MODELS 124, 126, 129, 140, 163, 168, 170, 201, 202, 208, 210, 220, 461, 463

Modification notes

28.9.99	Replaces SI 20/50 of 08.03.94	Please remove SI 20/50 from your file.	
---------	-------------------------------	--	--

P20.30-0202-01

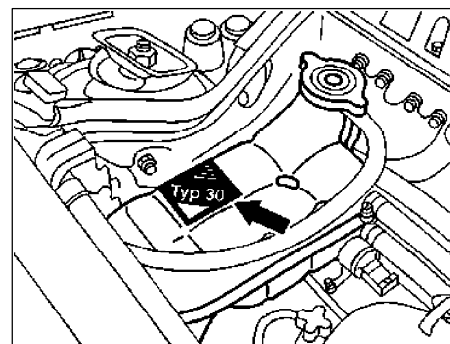
A special corrosion protection/antifreeze agent (KFM) type 30 is available for "aluminum corrosion in cooling circuit".

- 50 Vol. % water
- 50 Vol. % corrosion/antifreeze agent provides frost protection up to -37°C

ⓘ Fit warning sticker clearly visible on the expansion tank (see arrow)

ⓘ KFM type 30 must not be mixed with any other antifreeze agents
